From: Berry-Khan, Gabriel
Sent: 14 January 2021 20:55
To: McClue, Jonathan
Cc: Frost, Katherine
Subject: 2020/5774/P Murphys Yard EIS scoping - LLFA

Please find here comments on the flood risk and drainage theme.

The SFRA's soil infiltration compatibility map (below) indicates a mix across this site of very significant constraints (grey), opportunities for bespoke infiltration SuDS (darker purple), and high compatibility (lighter lilac).

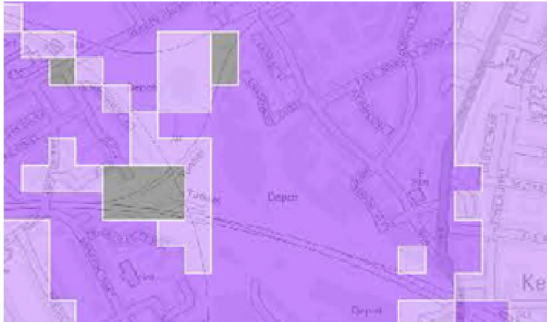
As such, we would expect to see infiltration tests undertaken at representative and promising locations, prior to the planning application, as part of the work done to prepare the Drainage Strategy.
